TITLE:  
ITEM NO:  
DESC.: PLAN, ELEVATIONS, DETAIL  
DESC.: CAFE PANTRY 3392

By: PD Scale: As Noted Job No. Dwg. No.  
Status: IN SUBMITTAL REVIEW Date: 2019-07-08 **02-01**

TITLE:	SECTIONS	Job No.	Dwg. No.
ITEM NO.:	CAFE PANTRY 3392	Scale: As Noted	02-04
DESC.:		Status: IN SUBMITTAL REVIEW	Date: 2019-07-08

TITLE:  
ITEM NO:  
DESC.: SECTIONS, DETAILS  
DESC: CAFE PANTRY 3392

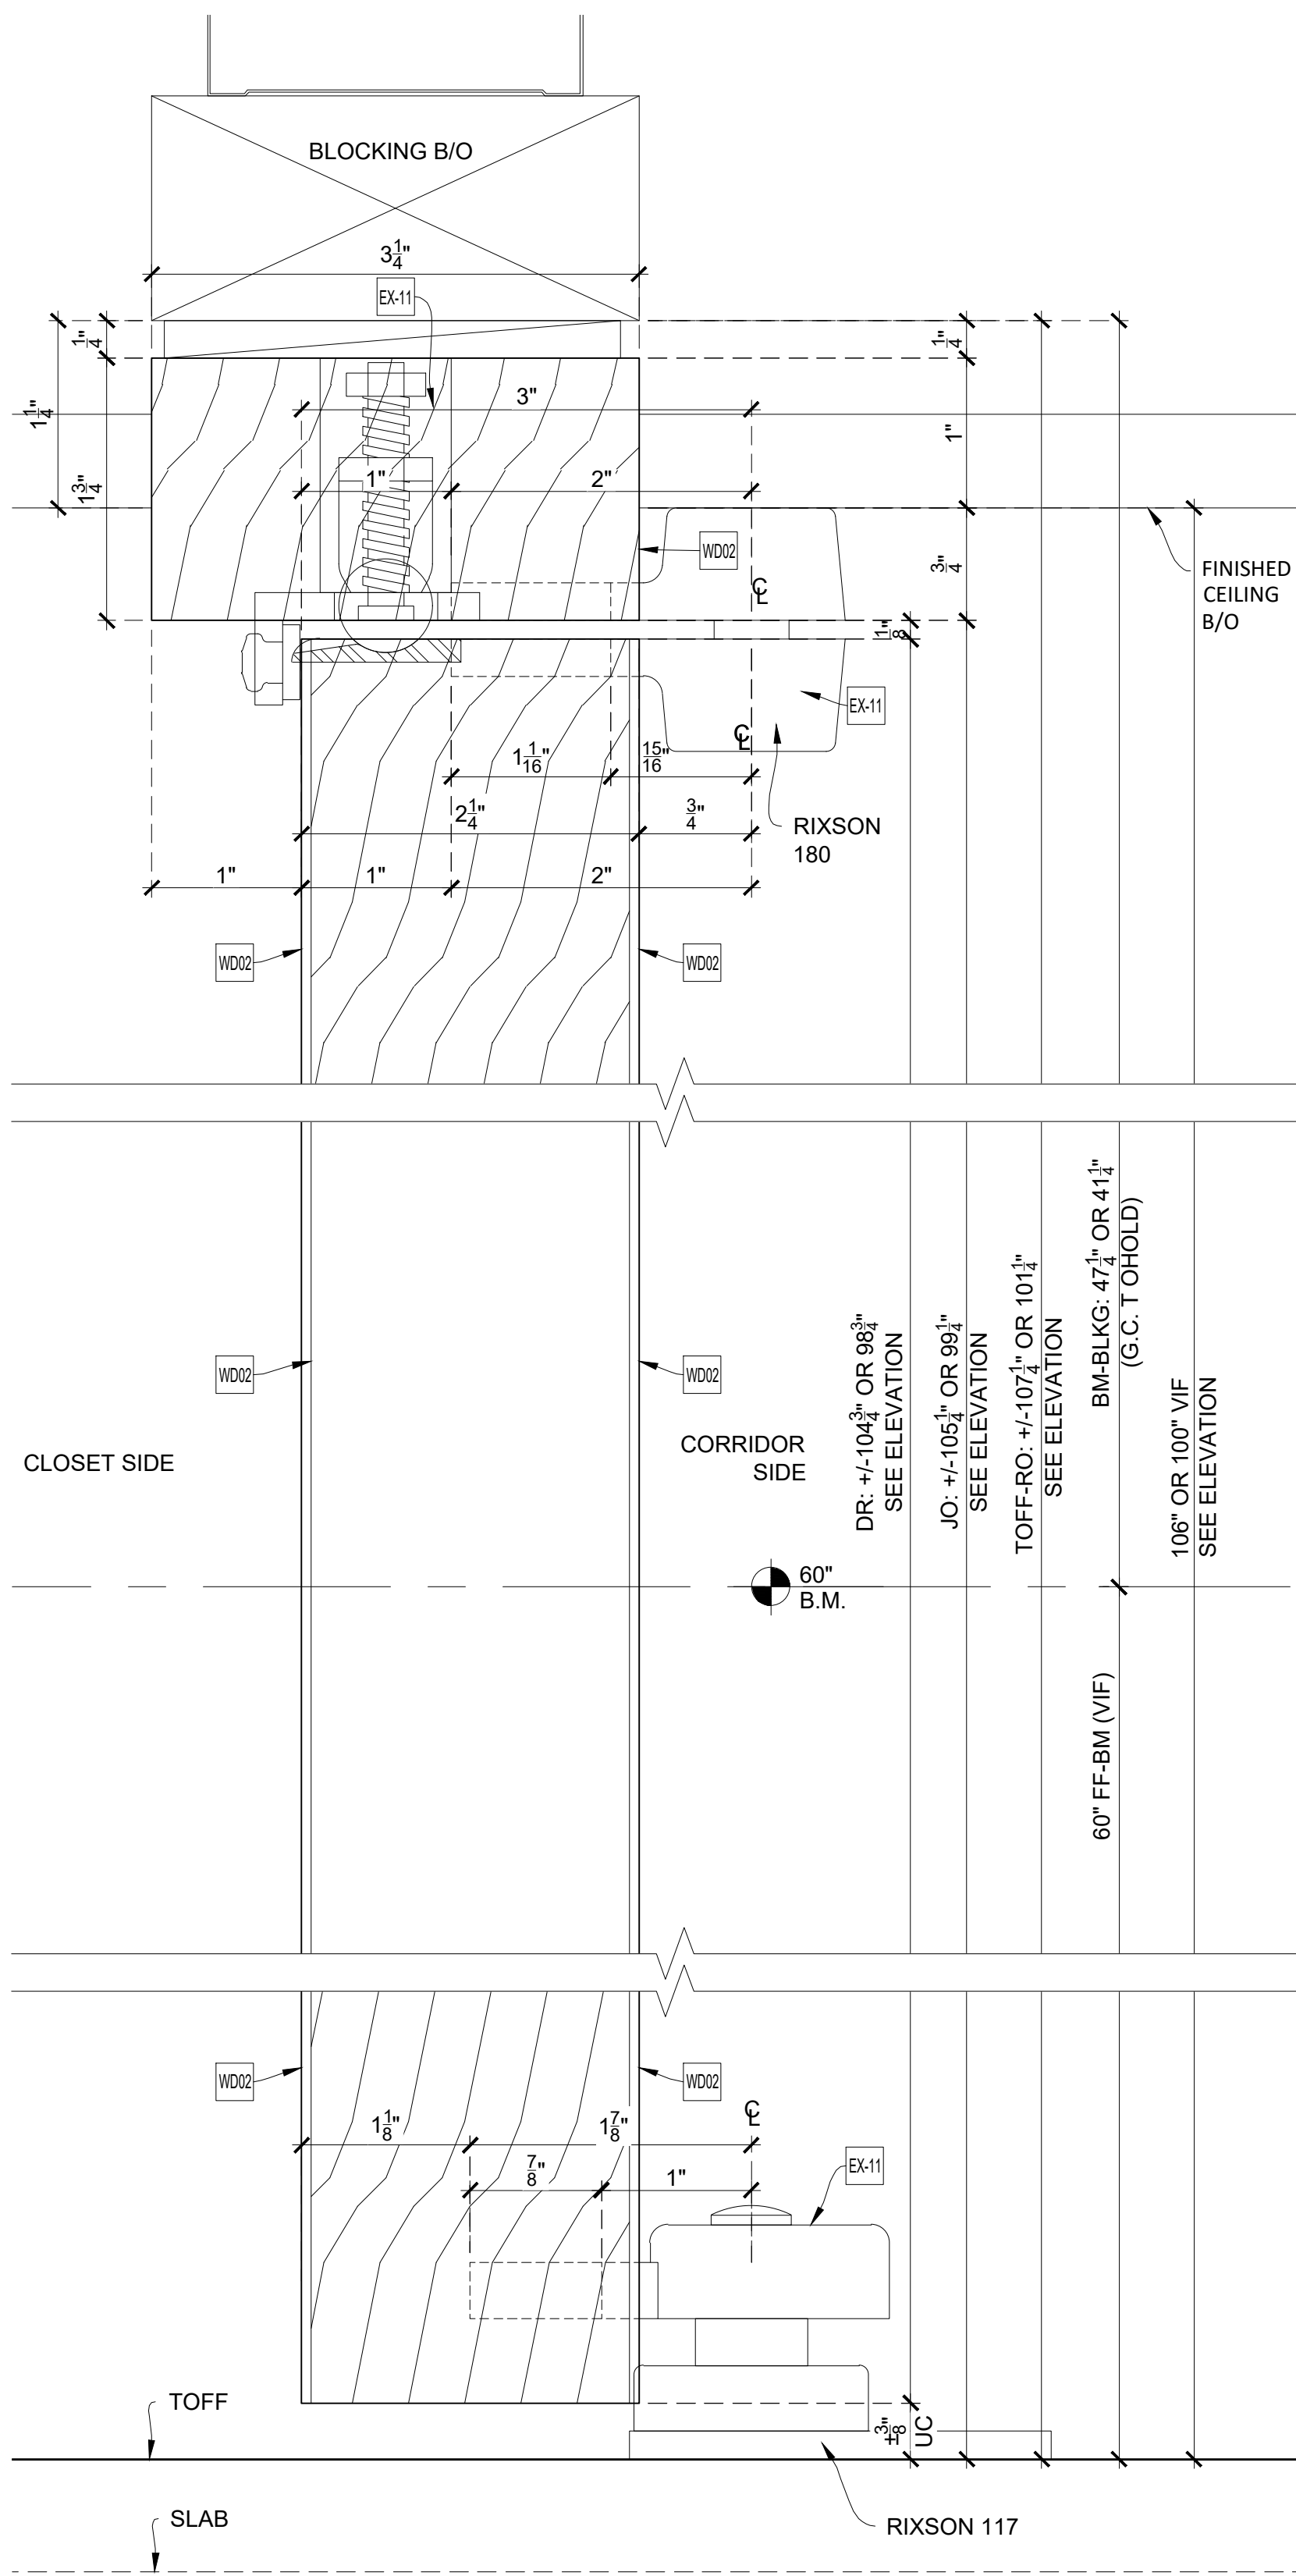
ARCHITECT NOTE:  
PLEASE VERIFY  
FINISHES

ARCHITECT NOTE:  
TO THIN LEG MBR RECOMMENDS  
METAL POWDER LEGS.  
PLEASE VERIFY.
